Item 6 - Correspondence

Re: CCCFH Comments on Kensington of Bethesda (Westwood II), Preliminary Plan and Site Plan, Planning Board agenda of December 17, 2020, Item 6

TESTIMONY OF LYNNE BATTLE AT THE DECEMBER 17, 2020 HEARING ON THE KENSINGTON OF BETHESDA SITE PLAN

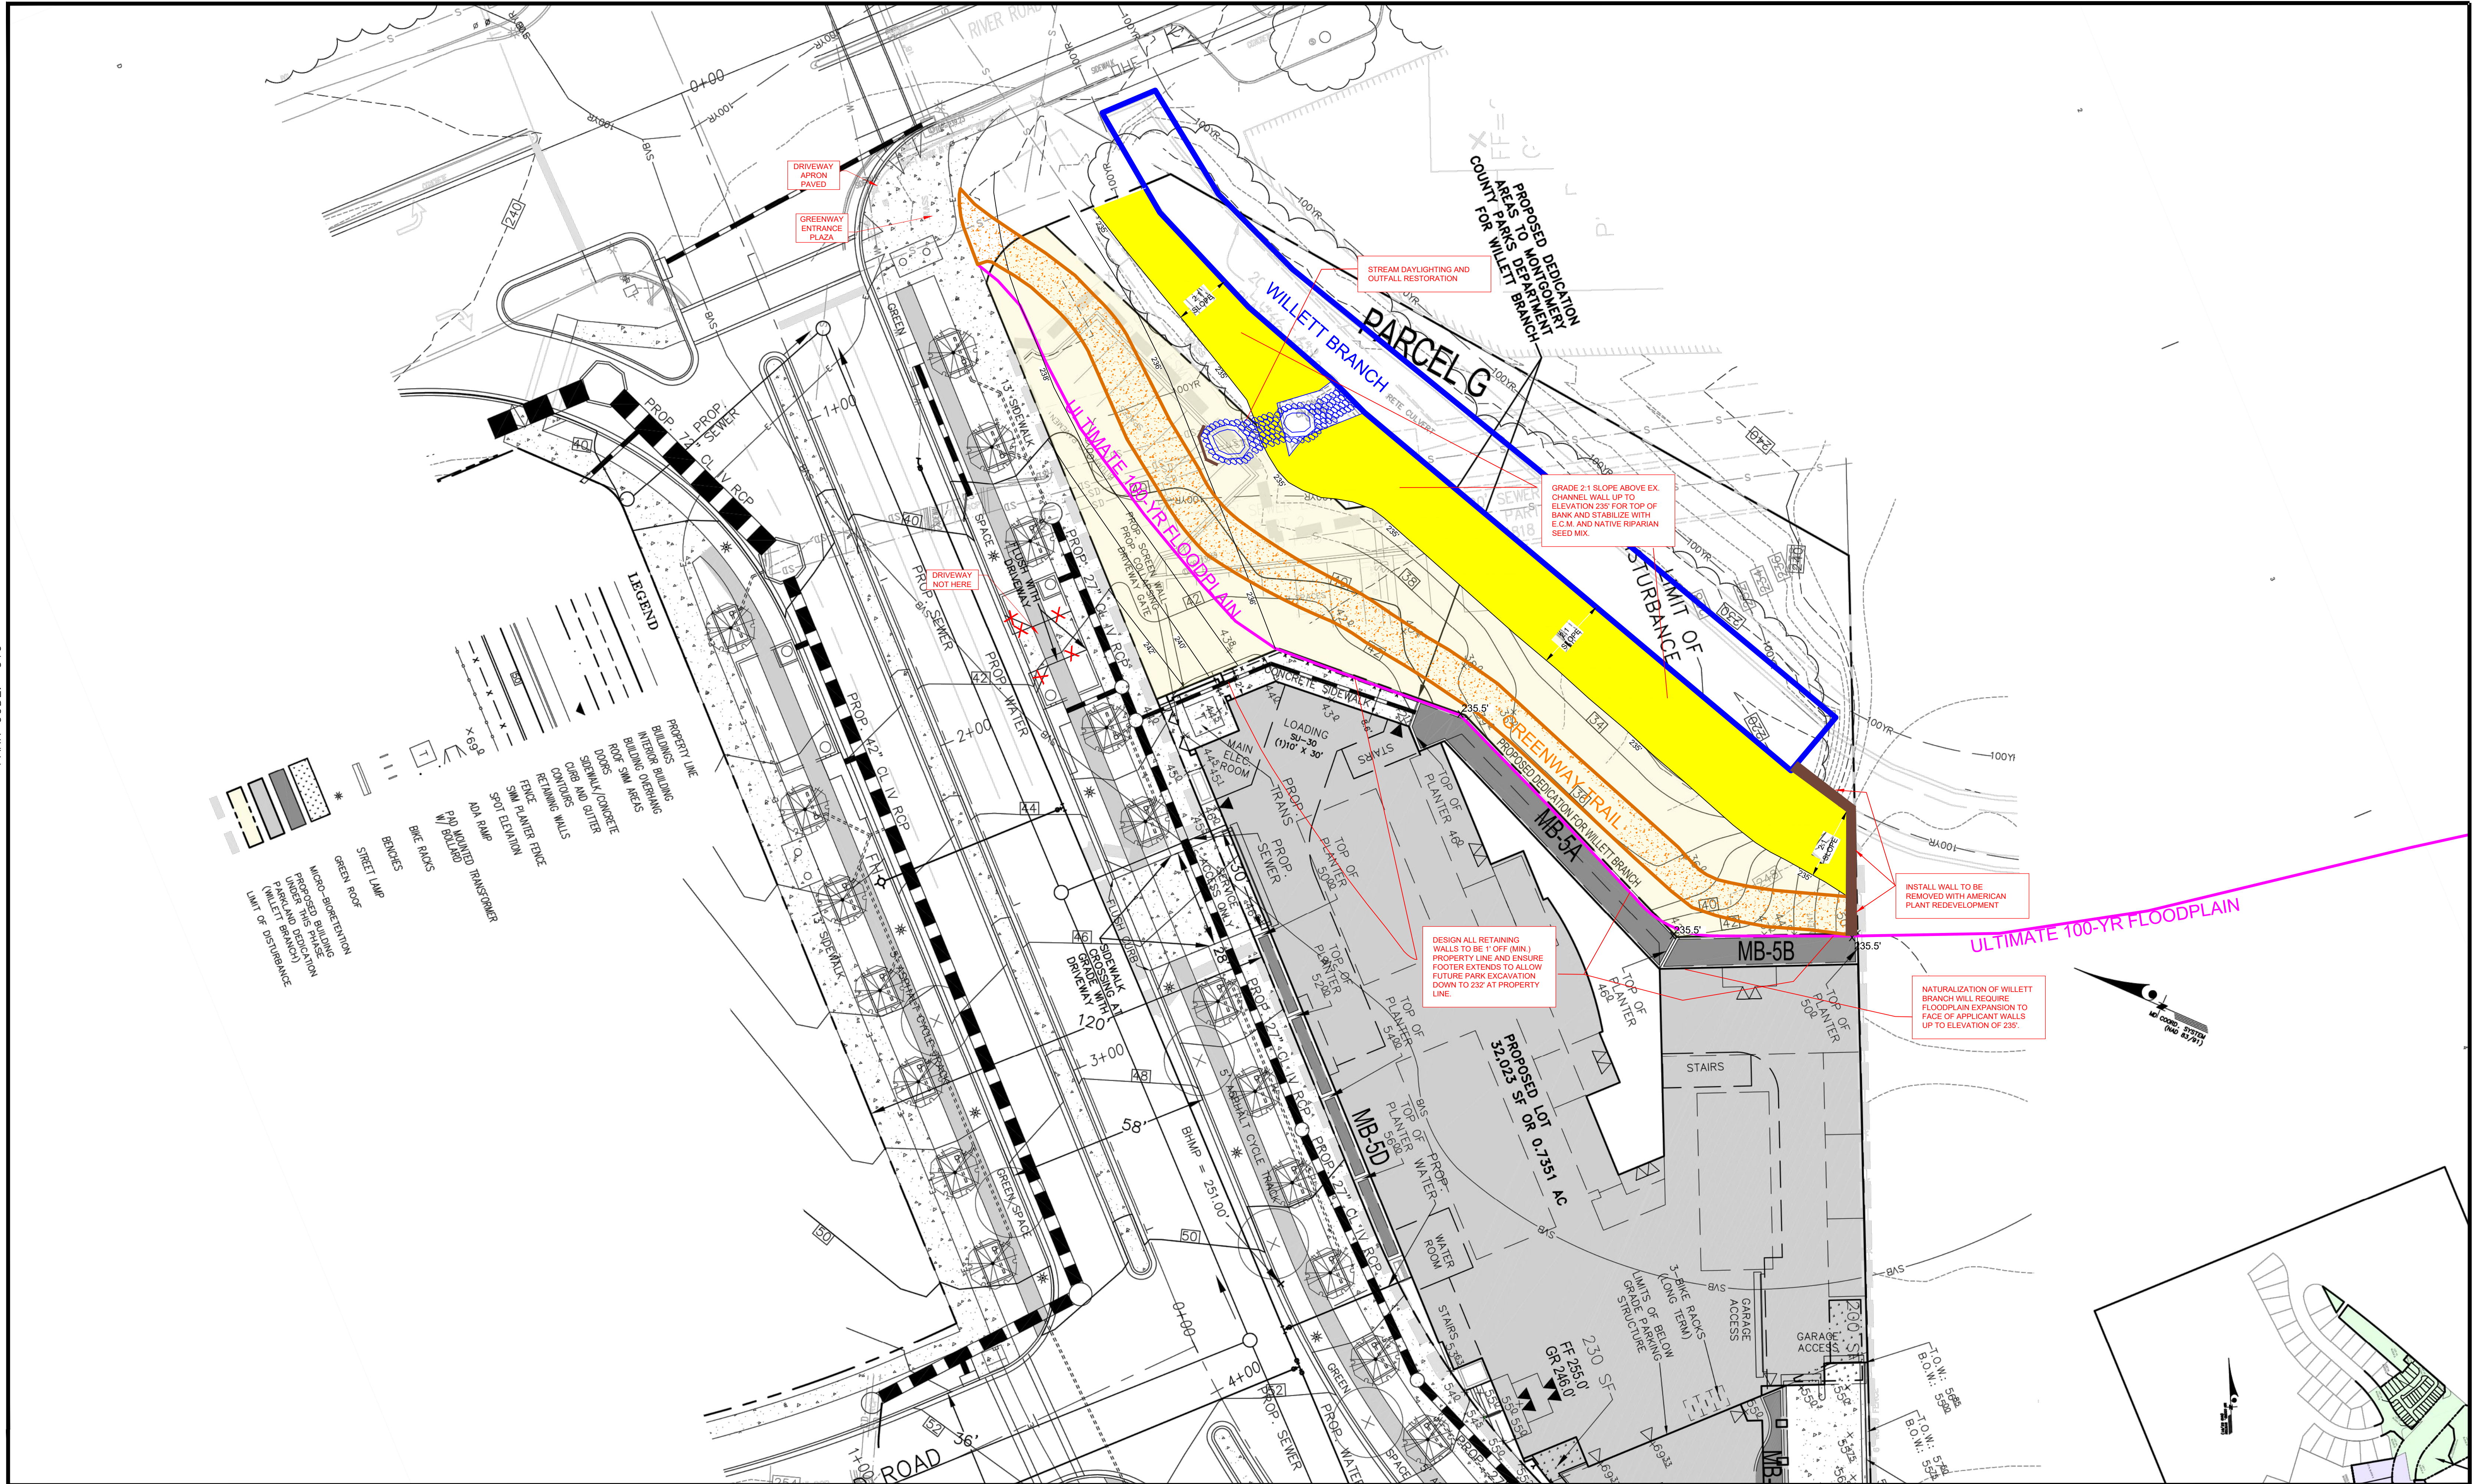
At a minimum, there are several major issues that require a traffic signal study at the above location:

- 1) The Department of Transportation did a sight study of trucks coming out of the Kensington of Bethesda delivery truck area on Westbard Avenue, but they did not do a sight study for vehicles and bicyclists coming along northbound Westbard Avenue, heading towards River Road. Just past the parking garage entrance of the Kensington, the road curves and dips, creating a blind spot for those coming around that curve.

- 2) Vehicles coming out of the Westbard Ave. Ext. heading left towards River Road will have to cross five lanes of traffic if the driver wants to make a right-hand turn onto southbound River Road. This turn will be right in front of the Kensington. Given the volume of traffic expected on northbound Westbard Avenue, this could result in numerous traffic accidents, upsetting for the drivers and residents in the Kensington.

- 3) Although the volume of traffic turning to and from the Westbard Ave. Ext. will not be as great as that going into and out of the North Access of the Westwood Shopping Center, a warrant study for the interruption of continuous traffic at the intersection of Westbard Ave. Ext. and Westbard Avenue should be done after the realignment of Westbard Avenue and the completion of the Kensington. Community members should not have to wait several years for Regency to reevaluate “the signal warrants following completion of the Westbard Shopping Center Development” per the planner’s report.
